Report on Spurwing Dam, Letata, Dullstroom

Cutwater Farms (Pty) Ltd

April 2004

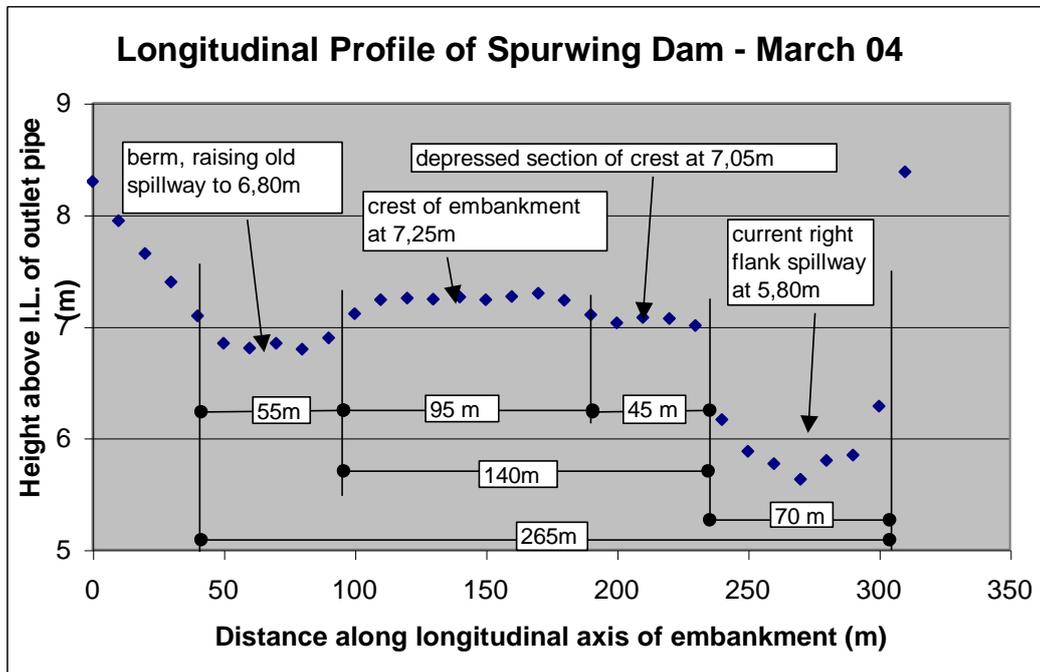
- Depth of Spurwing dam - Figure 1 shows that the right flank spillway is on average 5,8m above the outlet valve's invert level, which in turn is estimated at 0,6m above the riverbed. Thus the elevation of the water at FSL (the level at which water starts running down the spillway) relative to the riverbed is $5.8 + 0.6 = 6.4\text{m}$.
- Impoundment volume of Spurwing dam – Owing to the onset of darkness and a storm, there was insufficient time to accurately assess the capacity of the reservoir. However based on the many photographs that were taken earlier, the dimensions given in figure 1, and visual estimates of distances, surface area and topography, it appears that the capacity of the reservoir at FSL may be slightly less than 50000m³.

It is evident from figure 1 that the crest of the embankment is virtually horizontal. This is generally an indication of an embankment that was well compacted during the construction stage. All embankment dams consolidate (compact under their own weight with time) to a greater or lesser extent, and clearly consolidation will be greater where the embankment is highest. So for an embankment to still be virtually horizontal and not V shaped after 12 years implies that it was very well compacted at the construction stage. A well compacted embankment generally has good shear strength and hence the various forms of shear failure that are possible are most unlikely even for the increased forces associated with a possible overtopping event (to be discussed later). It also means that it will not erode as easily as would a poorly compacted embankment in the event of water flowing over the crest and down the embankment during overtopping.

As indicated in figures 1 and 3, there is a portion of the crest, approximately 45m in length, that requires additional material to raise it by approximately 0,2m, so that it is at the same elevation as the rest of the crest. This will enable the crest to act as an emergency spillway, for floods exceeding 1 in 100 years. A tolerance of plus/minus 25mm is acceptable for the final elevation of the crest. Once again this is a simple process of clearing existing vegetation, bringing in the correct ground, spreading over the existing crest, and compacting with relatively small roller vibrators.

The crest of the embankment has a few high and low spots (over and above what is mentioned in 7.4), as may be discerned from figure 1. This will require some trimming and filling in a few places. A tolerance of plus/minus 25mm is acceptable.

Figure 3 – Schematic Plan of Spurwing Dam indicating proposed scheme of work (7.1 to 7.6).

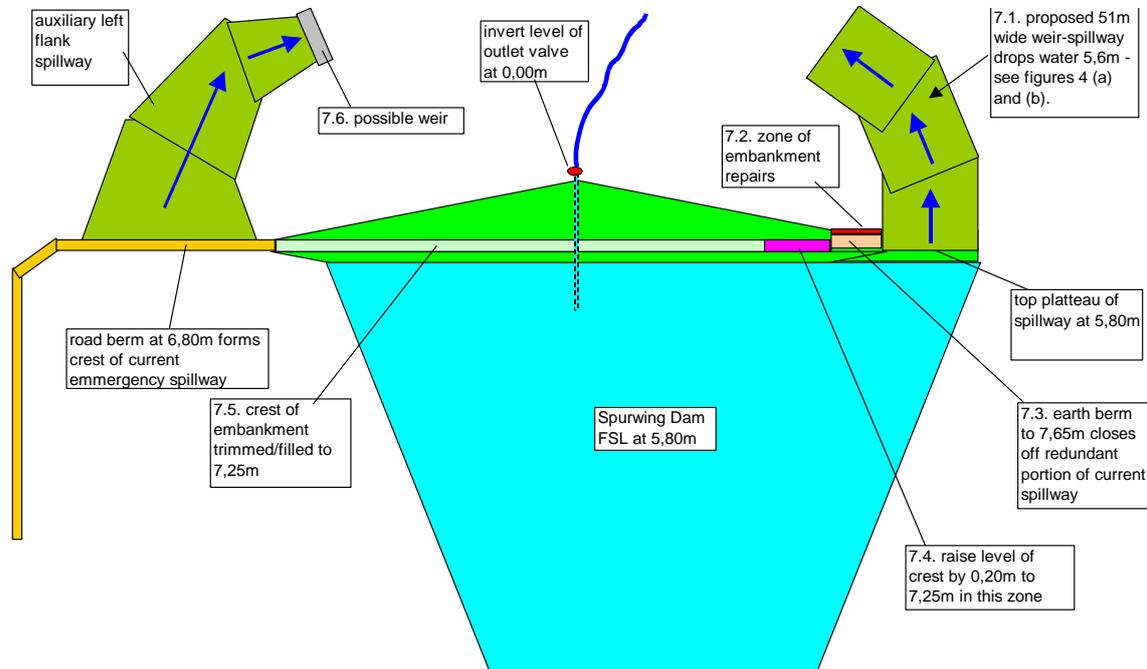
Six areas requiring attention have been addressed in the preliminary design. These may be located in figure 3 and are fully described in 7.1 through 7.6. The preliminary design is further supported by figures 4 through 7.

As indicated in figure 2 and 3 the effected areas are not large, and the repairs can thus be effected relatively easily with simple compaction equipment.

Once the repairs in 7.2 have been completed, an earth berm can be constructed on top of the existing spillway, starting at the point where it currently begins to descend, through to the gabion structure shown in figure 3. The berm will therefore be about 19m long, 3m wide at the top, and 1,85m high. This will not require vast quantities of ground, which can be sourced from the excavated channel of the re-engineered right hand

Consideration should also be given to constructing a weir in the auxiliary spillway as indicated in figure 3, even if it is to remain as the auxiliary spillway. At the point indicated the spillway descends steeply, and a weir (either gabion, or random-rock-masonry) that is designed to dissipate the energy would virtually eliminate maintenance. Note that this spillway will only start to function the moment the flow exceeds $86\text{m}^3/\text{s}$, i.e. above the 1 in 20 year RI flood. However, it may be decided that the cheaper option is to simply do periodic repairs, since generally the proposed weir-spillway on the right flank will cater for most events.

Figure 4 (a) - Section through longitudinal profile of weir-spillway showing where the various changes in elevation are likely to occur. Background structures are not shown.

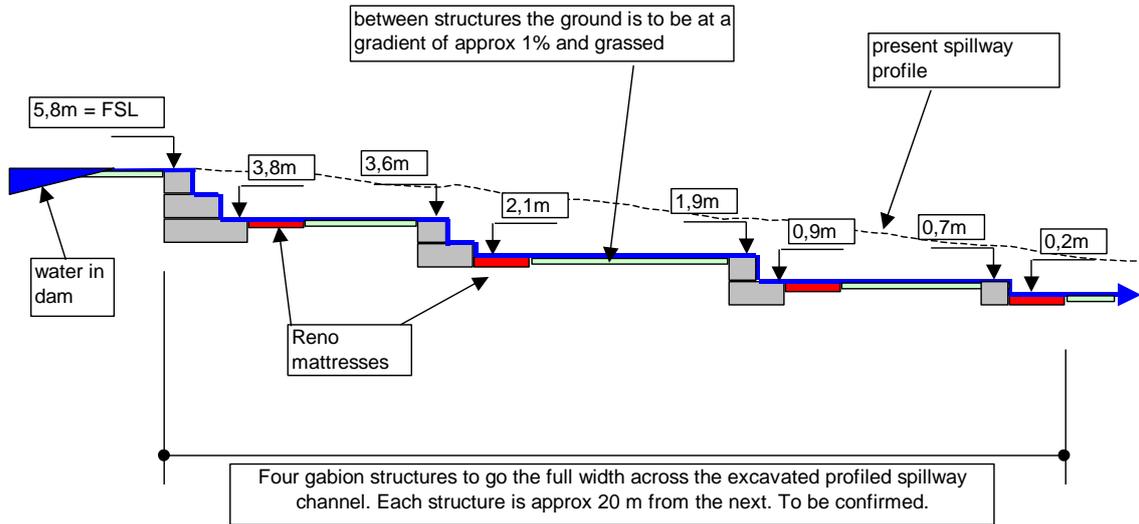
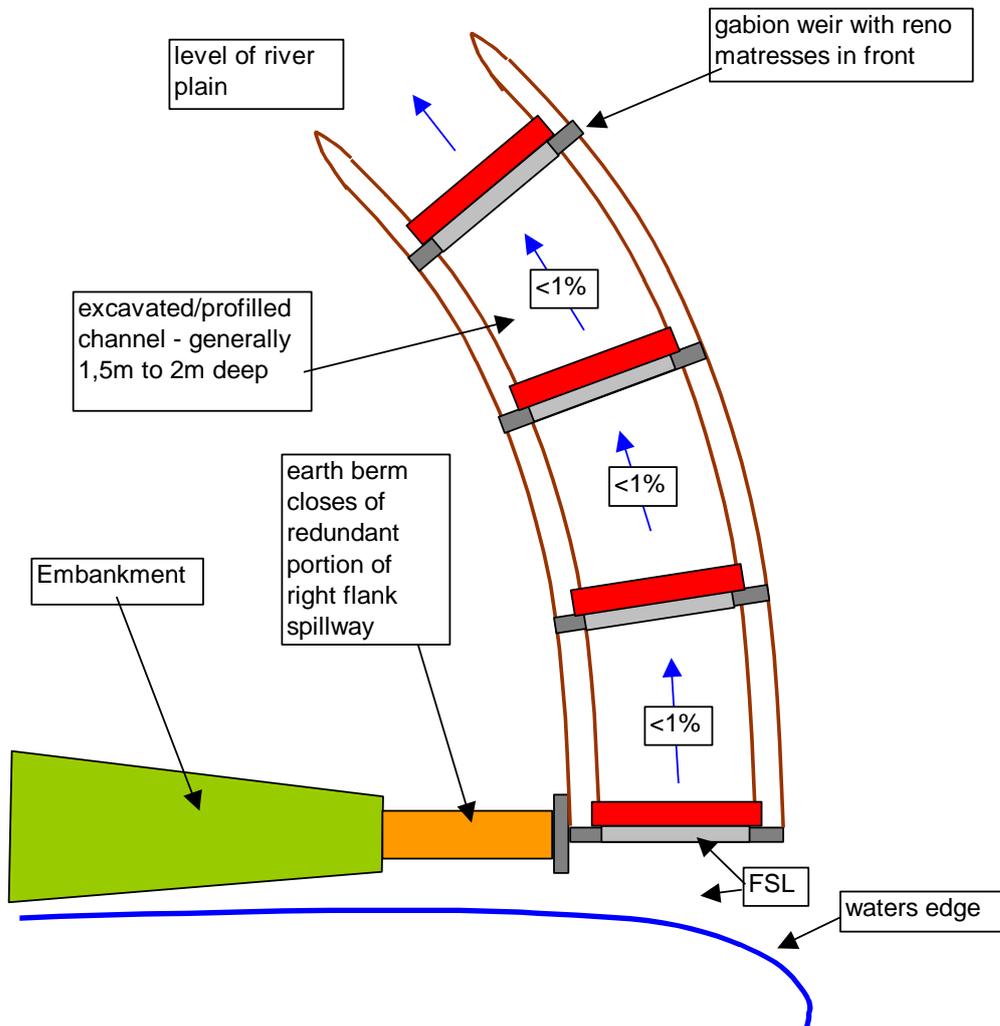
In section 5 a case for a 51m wide weir-spillway was made to serve as a means of conveying storm water around the dam. In this process the energy of the water is dissipated by lowering it 5,6m from the elevation of 5,80m (FSL) to a safe 0,20m via four weirs (see figure 4(a)) strategically positioned in an excavated/profiled channel (see figure 4(b)). All levels are referenced to the invert level of the outlet valve at 0,00m. Between the weirs the excavated channel will vary in depth from approximately 1,5m to 2,5m, and have a gradient not exceeding 1%. The total length of the spillway is expected to be of the order of 60m, and the weirs are spaced approximate 20m apart.

The cost of a 51m wide spillway that effectively has four step-down weirs (see figure 4 (a) and 4 (b)) and has an associated excavated channel that is approximately 60m long, may prove to be too costly.
